City of Biddeford
Planning Board
February 05, 2020 6:00 PM City Hall
Council Chambers,

PLANNING BOARD REPORT

PLANNING BOARD REPORT

RE: NEW BUSINESS ITEM #D – 2020.01 Final Site Plan Review/Shoreland Zoning Review for Biddeford Riverwalk Community, LLC for a proposed Parking Garage located at 3 Lincoln Street (Tax Map 71, Lot 2) in the MSRD-3 zone.

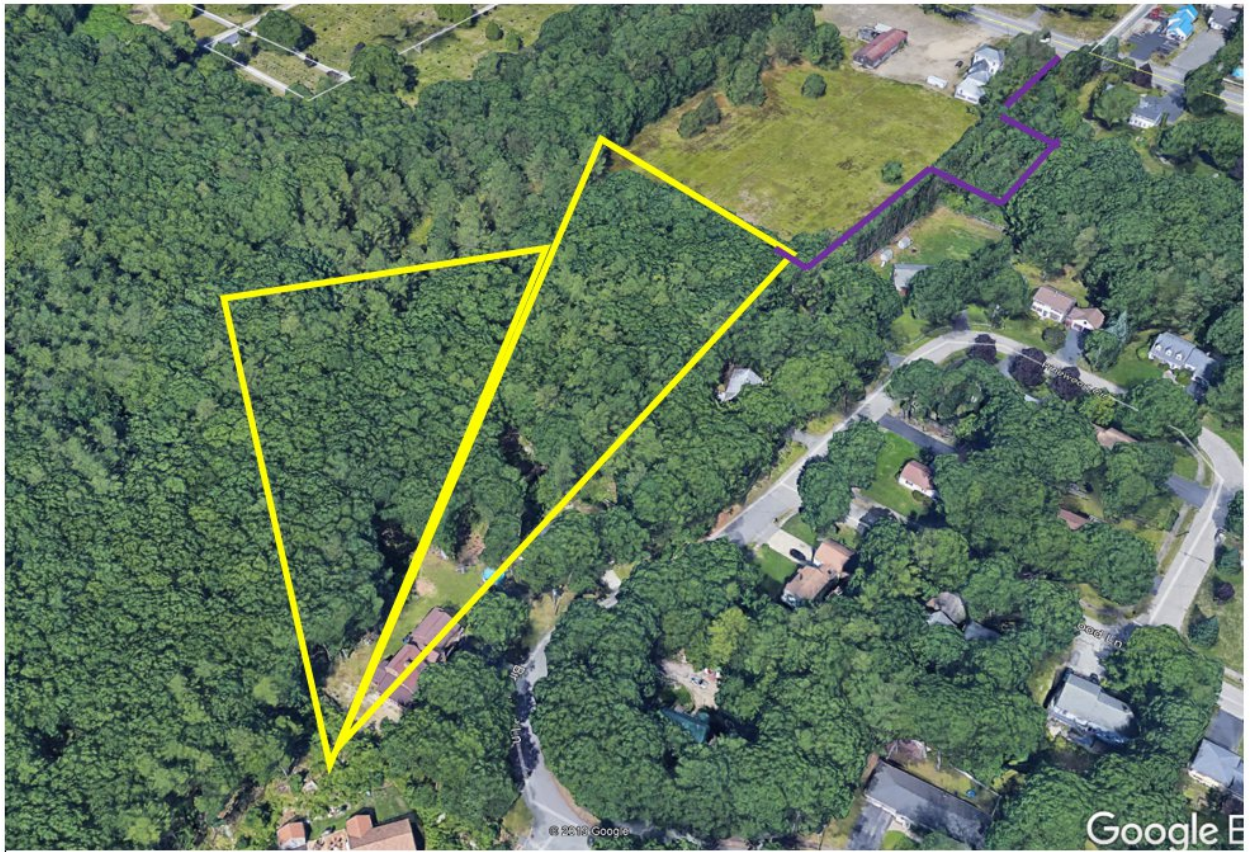
Here is an aerial of the area, including the project site. Note that the project development area includes a parking lot that extends to approximately the existing tree line today between lawn and woods. The proposed fencing extends along the northern property line (off-set) to the rear limits of the main parking lot. Just wrapping around the corner.

Essentially, based on the submitted plan, the fence extends along the northern property boundary where the parking lots borders those properties. Where the

parking lot border to the woods to the rear (towards Hill Street), the property is naturally vegetated and wooded.

Is the Planning Board comfortable with the buffer provisions indicated on the plans, including a 6' tall privacy fence as depicted on the plans?
